Outline Planning Application – LLFA Consultation Response

| SUBJECT: | Consultation Response – S62A/2022/0012 - Land East of Station Road, Elsenham | | |
| PROJECT: | Our Reference: 70084697 - Elsenham Stage 2 | AUTHOR: | [REDACTED] |

Figure 1 – Soakage testing location plan

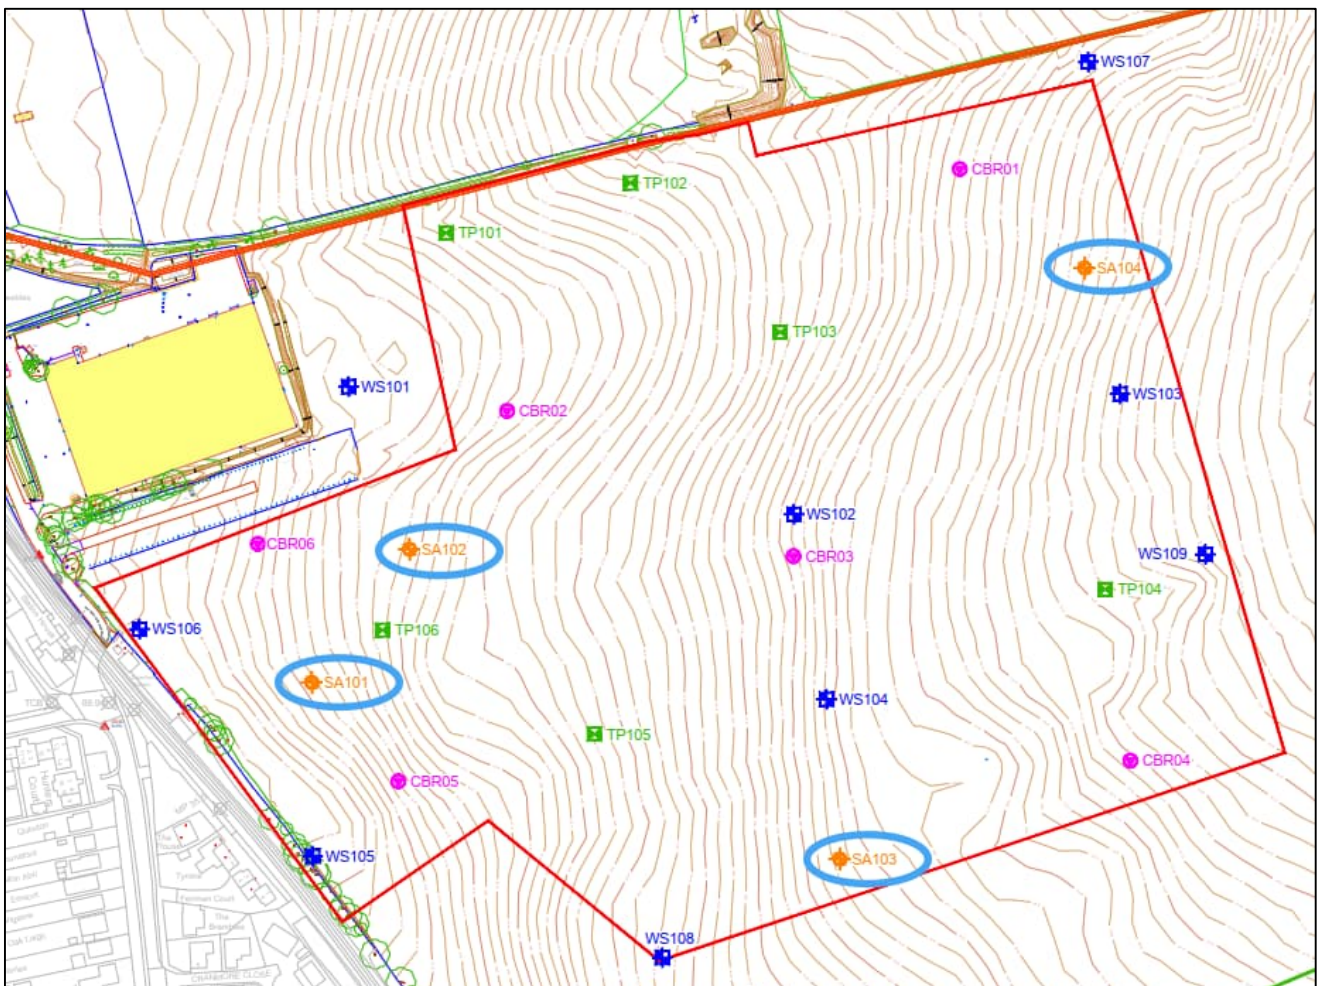
LLFA comment: The geotechnical site investigation report suggests that there are reasonable infiltration rates recorded beneath the central/southern portion of the site. This may lead to the possibility of shallow soakaways being possible and that further investigation will be required. Please clarify the reasons as to why this has not been proposed on site in line with the surface water hierarchy?

The Ground Investigation report reference 1921748-R02 (00) by RSK in Appendix B of the FRA shows four soakage tests in various locations across the site noted as SA101, SA102, SA103 and SA104. Results are summarised in Table 2 below.

Results show that three out of four of the soakaway locations failed the test in accordance with BRE 365, which indicates that infiltration would not be viable across most of the site. Only a small, isolated area within the Kesgrave Catchment Group along the southern boundary may be suitable for infiltration.

Due to limited viability of infiltration to ground, in accordance with precautionary principle set out within the NPPF, the outline surface water drainage strategy is based upon the principle of surface water disposal to an existing watercourse only.

Further limited testing will be undertaken post planning to refine the current baseline information, however with the information available to date, it should be noted that this will not change the over-arching drainage principles set out within the outline application, i.e. for any paved areas located within sufficient soakage zones, the proposed lined permeable pavement could be changed to un-lined to enable a quantum of water to discharge directly into the receiving sub-soil.

INSET A
TYPICAL PERMEABLE PAVING ARRANGEMENT
NOT TO SCALE

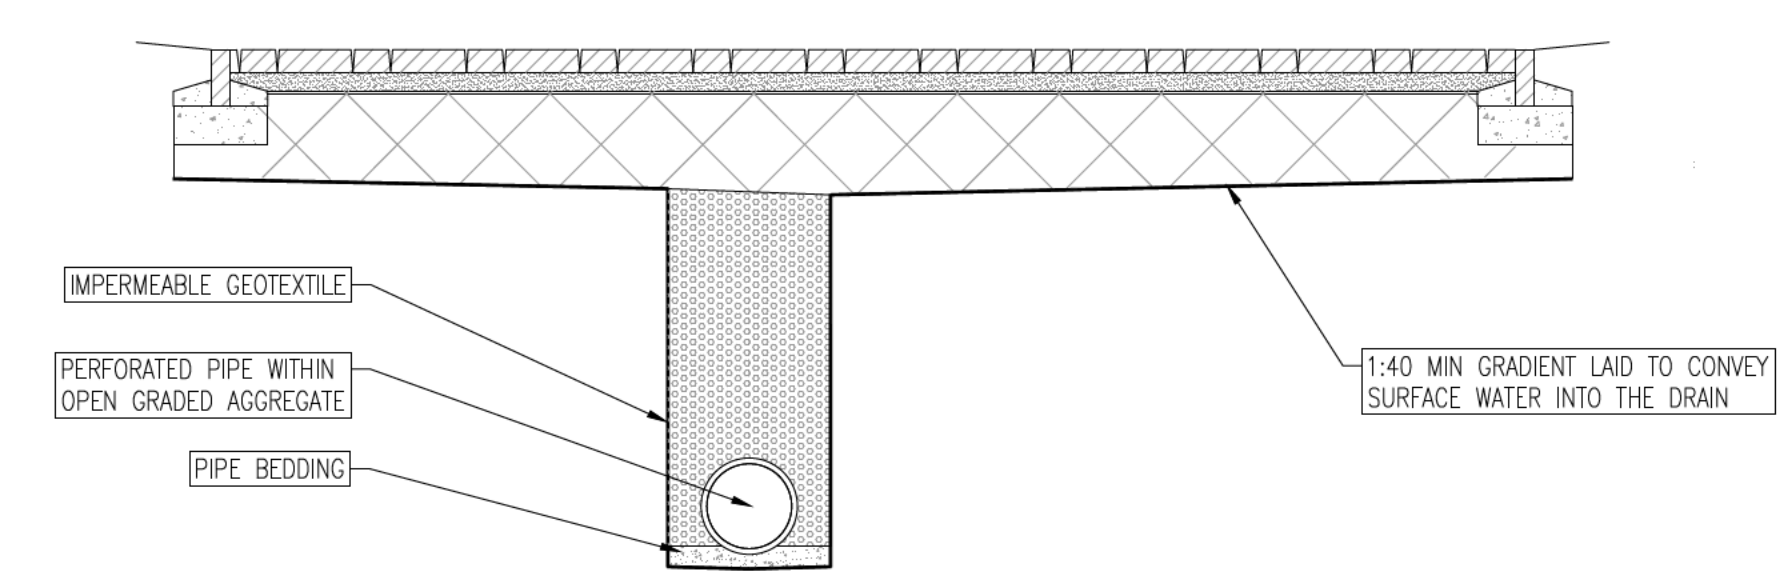
LLFA comment: Clarify the discharge location for permeable paving on site. Whilst permeable paving has been detailed within the FRA, the areas have not been input within the surface water design calcs.

As detailed in Note 10 of Drainage Strategy drawing 4697-WSP-00-XX-SK-D-0902-P01 shown in Appendix G of the FRA, the permeable pavement will be lined and discharge, via perforated pipework, to the proposed surface water system.

Proposed permeable paved areas are included in calculations in Appendix H of the FRA, as summarised on Table 1 of this Technical Note. The permeable pavement is included for conveyance and sediment control only and will not be used for attenuation storage. Therefore, calculations for the permeable pavement have not been included in the FRA.

To assist, a typical detail setting out the design intent of the lined permeable paving has now been added to the Drainage Strategy drawing 4697-WSP-00-XX-SK-D-0902-P02. Refer to Appendix A for details.

INSET B
SW OUTFALL ARRANGEMENT
SCALE 1:500

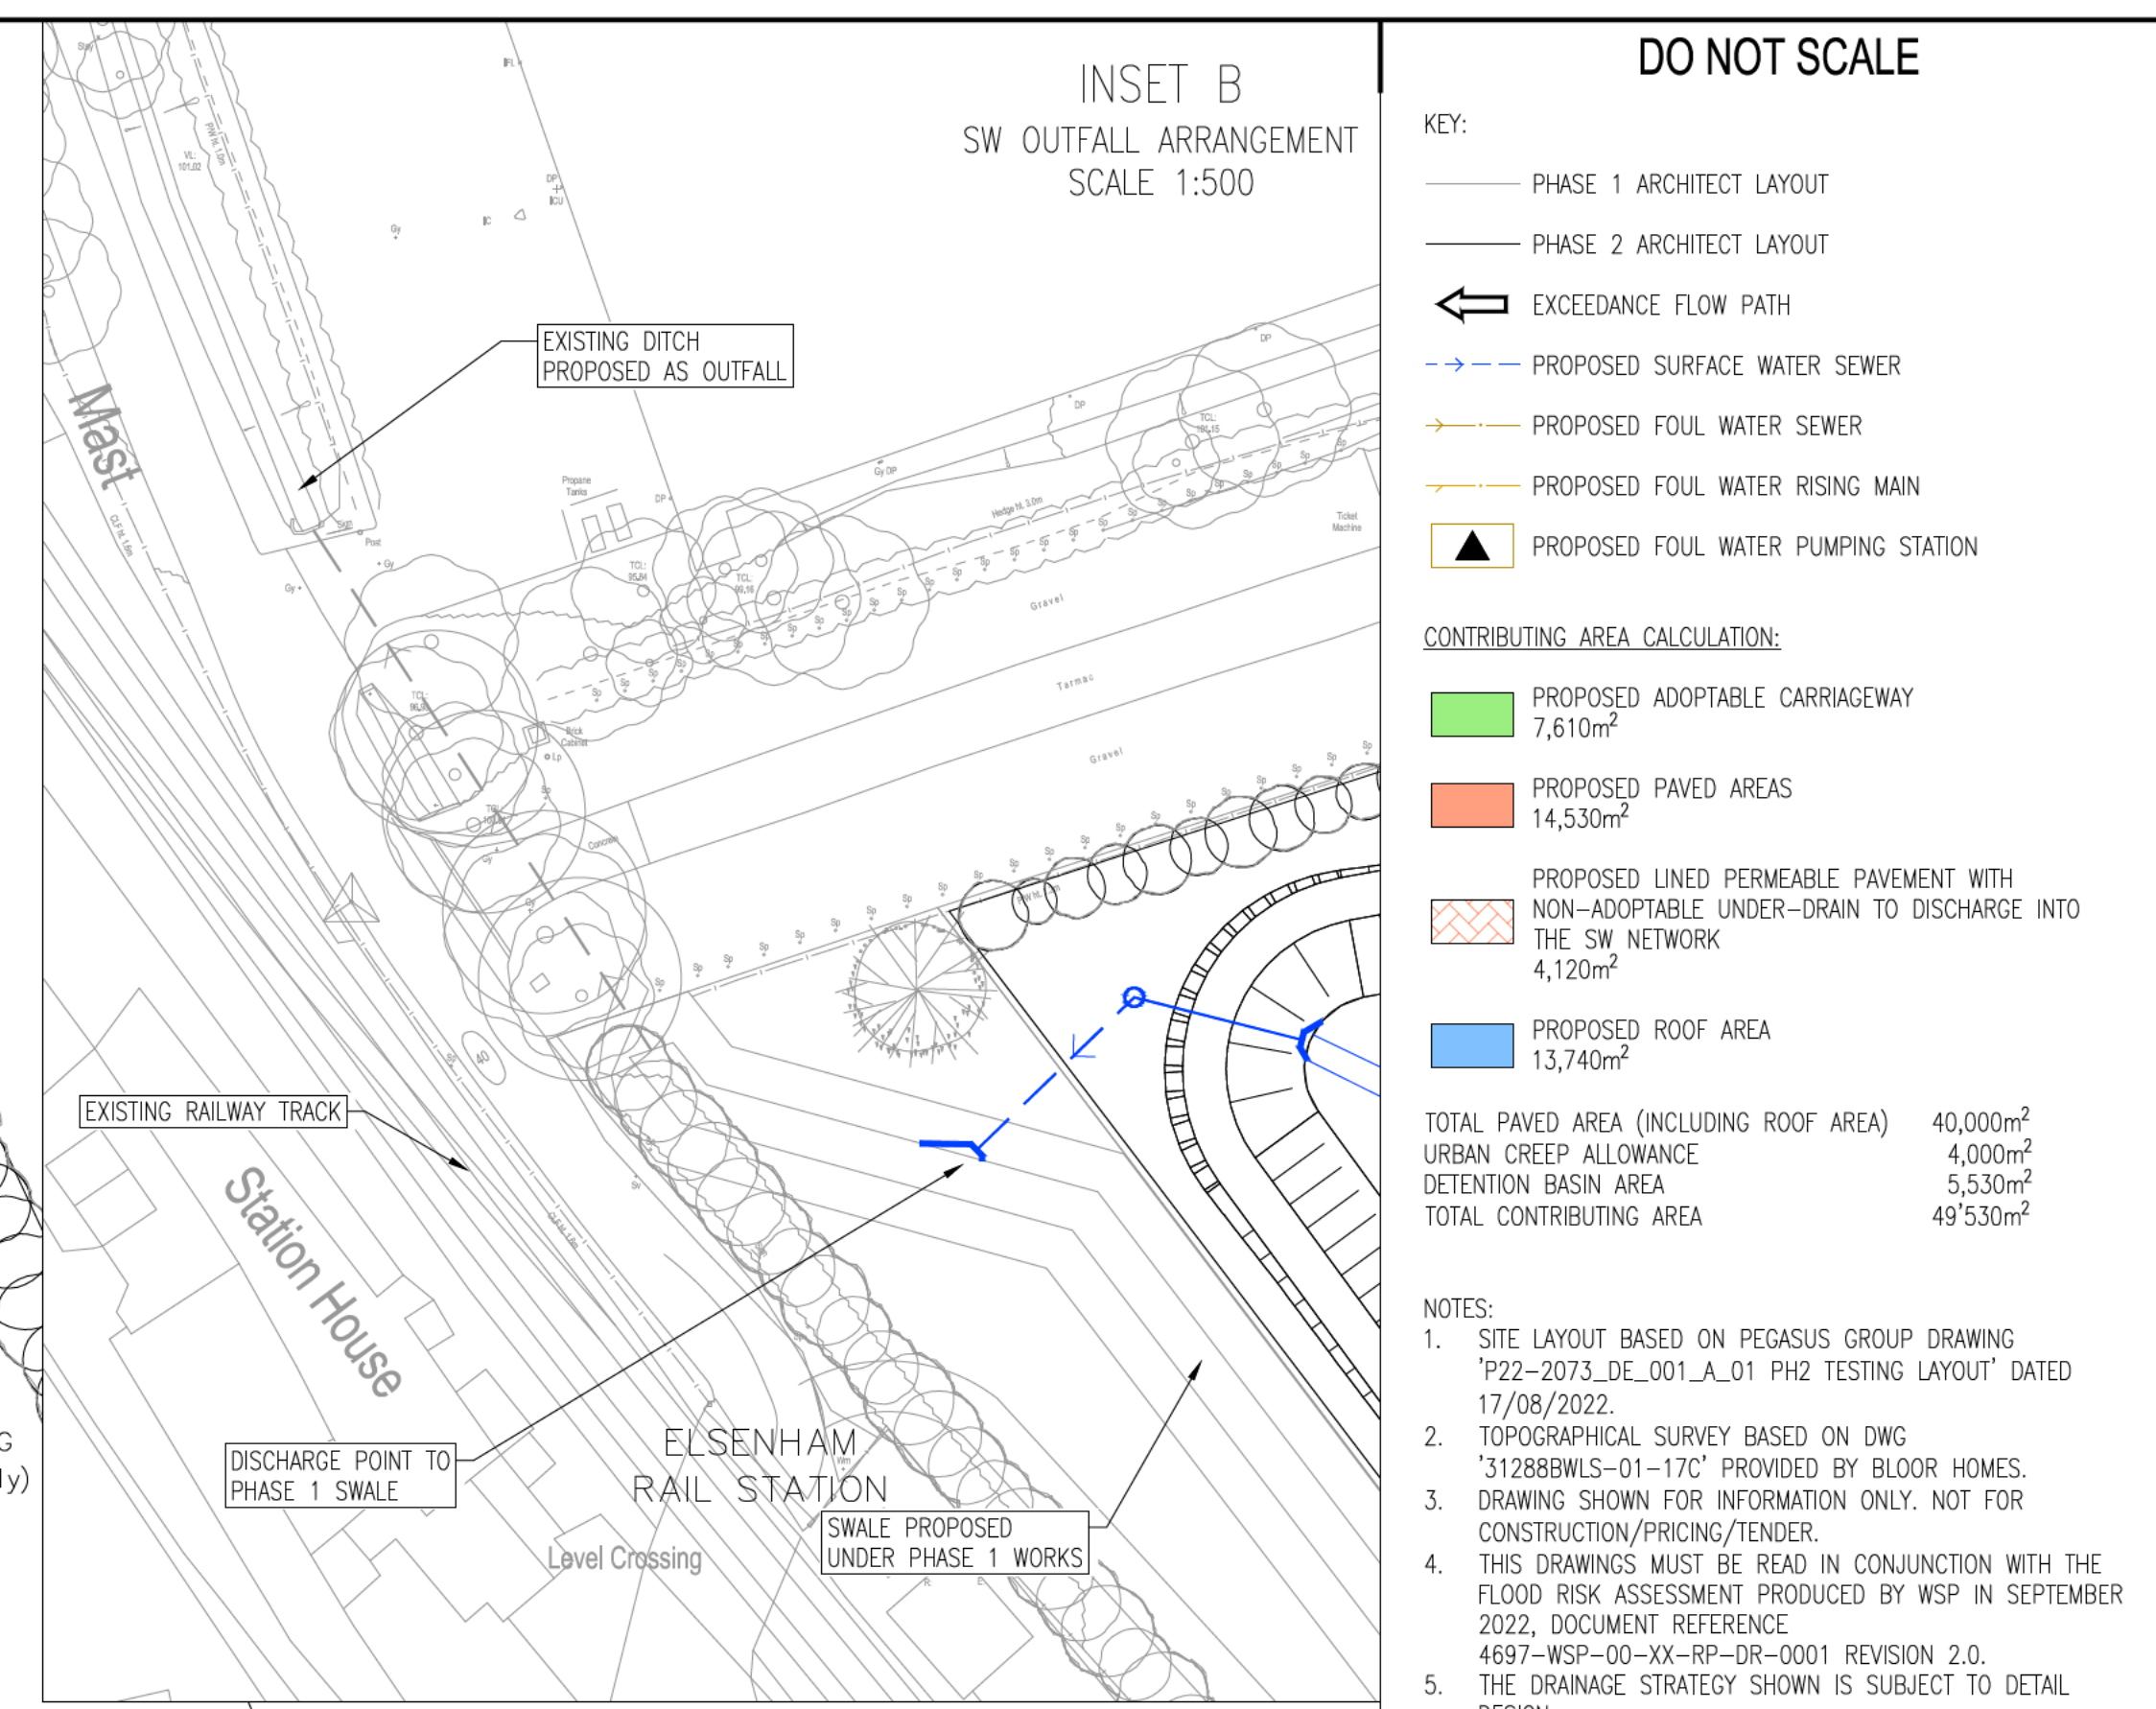
LLFA comment: In line with the Simple Index Approach for water quality the pollution hazard indices is incorrect in that due to the amount of dwellings proposed on site the traffic movements will be above 300 and as a result the hazard level will be classed as medium. As such there are not enough treatment stages proposed. I am aware that permeable paving is proposed in areas however this does not look to have been detailed with the SuDS mitigation indices.

Therefore, the combination of the detention basin which will accommodate low flow ‘rills’ and sediment forebays in conjunction with the swale (which provides additional passive treatment) demonstrates that the selected SUDS mitigates the “medium” pollution hazard level. Refer to Table 4 below for details:

For clarity, further detail has been added to the detention basin setting out the design intent of the low flow ‘rills’ and sediment forebays as shown on Drainage Strategy drawing 4697-WSP-00-XX-SK-D-0902-P02. Refer to Appendix A for details.
